## Sienna Construction Note 6/22/10

### AM Receive Sensitivity Improvement

#### AM receive sensitivity improvement

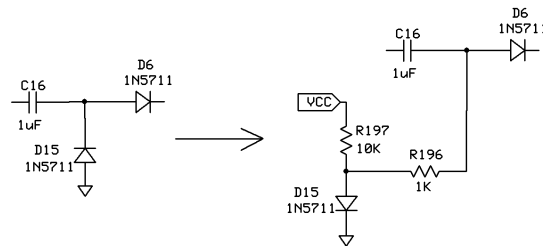
**Problem:** AM receive has a kind of “squelch” effect, in which tuning between AM stations results in no audio from the speakers. Once a station is tuned in, it comes in fine, but no noise is heard between stations.

**Solution:** Add a biasing circuit to the AM detector diode on the receiver board. See schematic and description of fix below.

#### Remove D15

In the round pad where D15 was, place the cathode end of D15, pointing the anode up

In the square pad where D15 was, place a 1K 1/8W resistor, pointing the other end up

In the small via next to R93 (immediately next to D6, directly below R93) place a 10K 1/8W resistor, pointing the other end up

Solder the top of the two resistors and the diode together (in the air)

NOTE: The instructions above apply to Rev B boards. If you have a Rev A or A1 receiver board, use the via above R48 instead of R93 in step 4 above.
